**Harris Nuclear Plant Pre-Submittal Meeting    March 2, 2017**

# License Amendment Request for Emergency Diesel Generator Surveillance Changes

**NOTE:** Technical Specification mark-up pages for this license amendment request are provided on pages 20-25 of this document for reference with the presentation material.

## **Reason for Change: Full Load Rejection Test Voltage Limit**

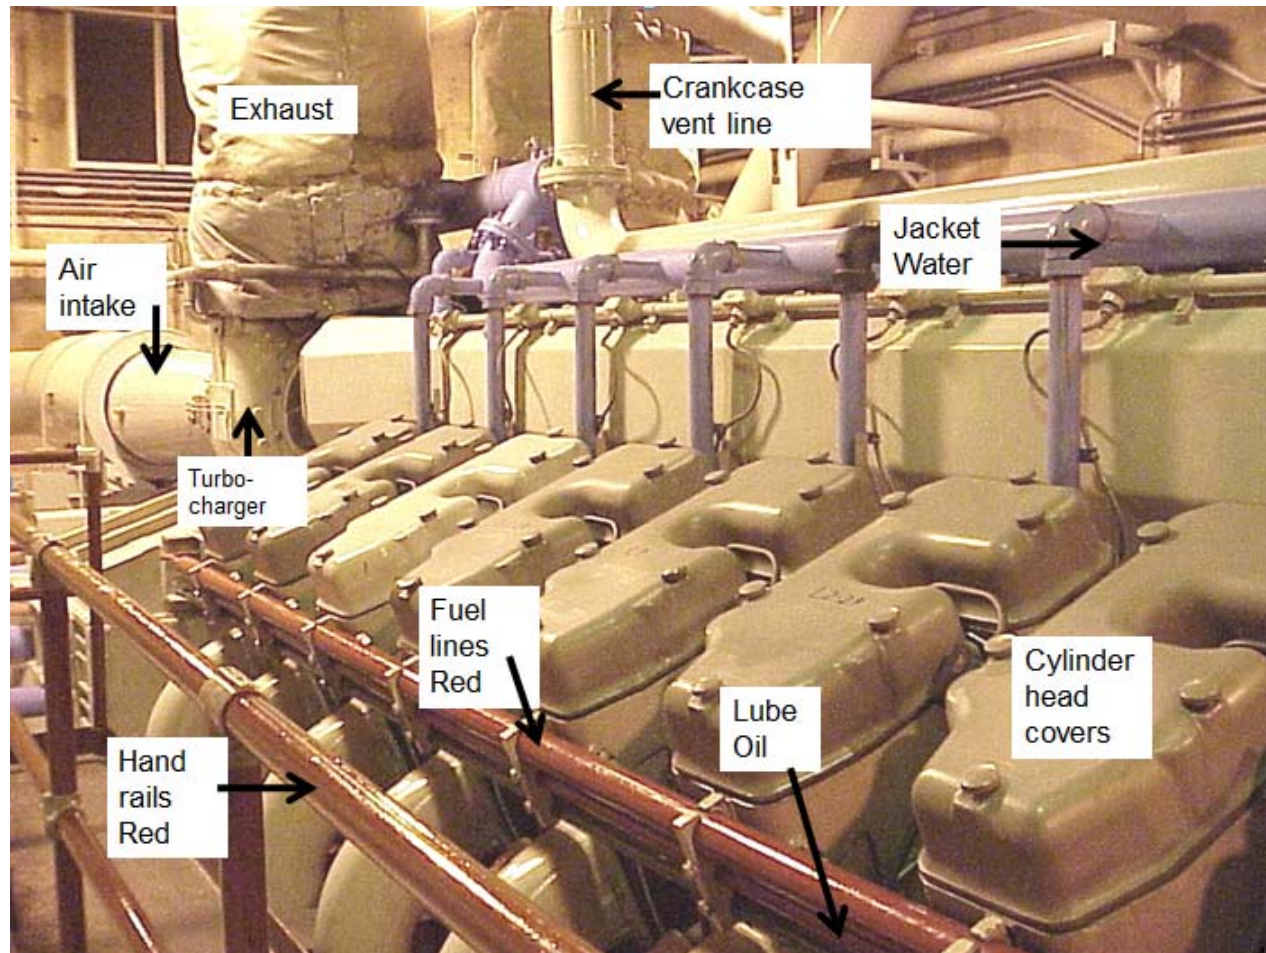
- Change to full load rejection test limit is necessary to gain margin. Previous results have shown that inadequate margin exists.
- The test requires that the EDG be paralleled to the grid just prior to load rejection. This reduces margin by approximately 2.5-3.0% due to the EDG being in the “droop” mode.
